TRANSMITTER

TY-D1323

Drawing No. T1262

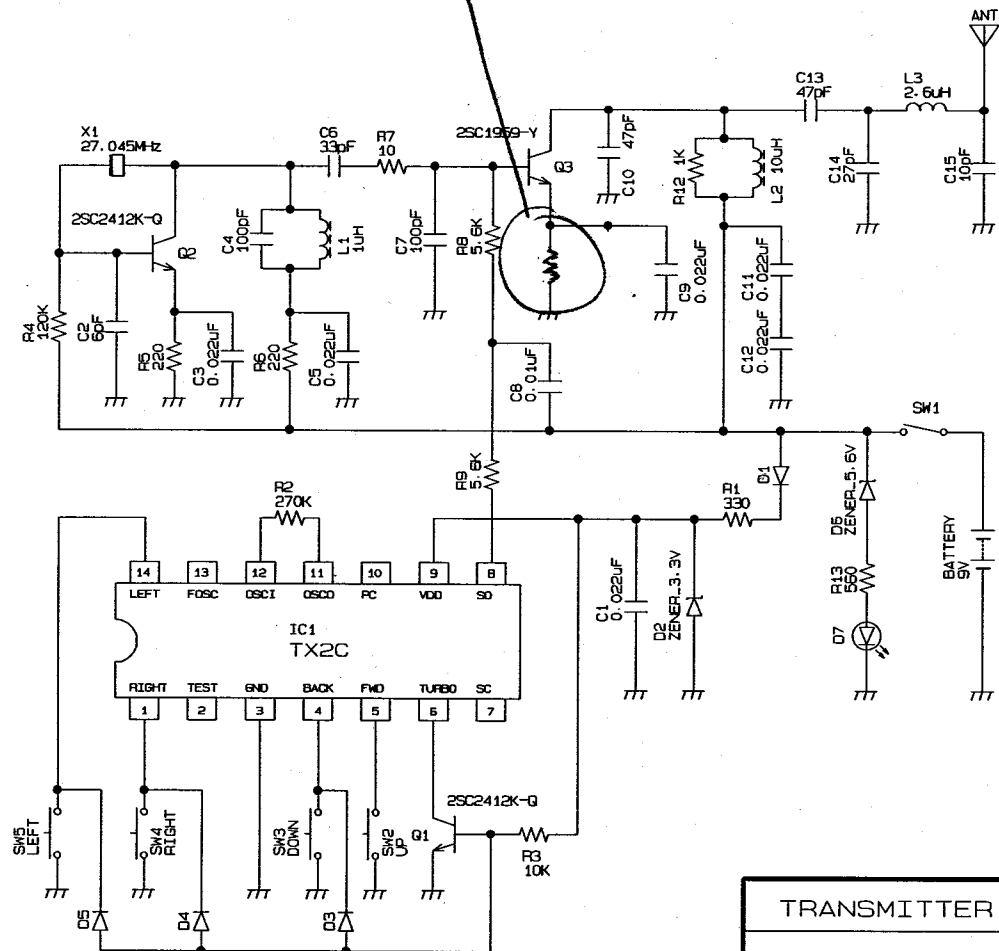
REMOVE R11
 Changed R10 to 220Ω (ohm)
